**EXHIBIT 1  
CITY OF MILL CREEK  
DEPARTMENT OF COMMUNITY DEVELOPMENT**

**STAFF REPORT  
TO THE CITY OF MILL CREEK HEARING EXAMINER**

**NAME OF PROJECT:** Muttley Square  
File No. PL2018-0017

Landscaping:

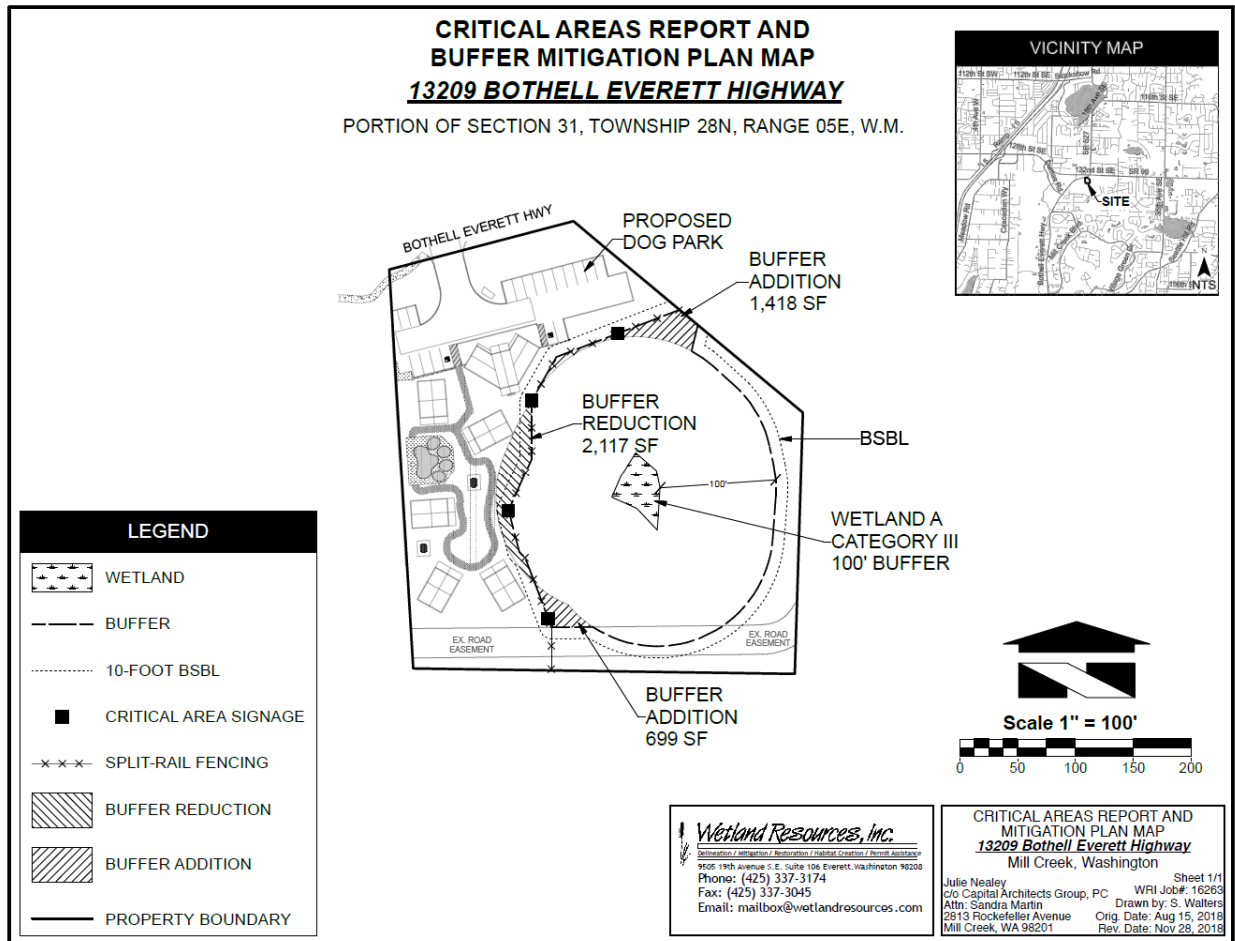
Where feasible, existing on-site significant trees will be preserved and protected during construction. The existing street trees along the SR 527 frontage appear to be in poor health and will likely need to be replaced as part of the landscape plan review and approval by the City's Design Review Board. As required by MCMC 17.16.085, the applicant is proposing landscaping in the 35-foot roadway buffer as well as around the perimeter of the parking lot. In addition, a landscape island is required between every 10 parking spaces, MCMC 17.34.040.H.2.E. The applicant is also proposing a dog exercise area with two picnic tables and walking path for the dogs between the five boarding houses. A Condition of Approval has been added under the Parking section above to address need for an additional landscape island and the potential loss of one parking stall.

7. The developer shall provide a secured performance bond equal to 125 percent of the cost of labor and materials, in accordance with MCMC Section 16.16.040, posted prior to the issuance of the first building permit.
8. The developer shall revise the civil plans, final Binding Site Plan and the landscape plan to provide a landscape island between every ten stalls.
9. Once the developer has fulfilled the obligations of the landscape performance bond, the applicant shall enter into a two-year maintenance bond for the approved and installed landscaping in accordance with MCMC Section 16.16.090.
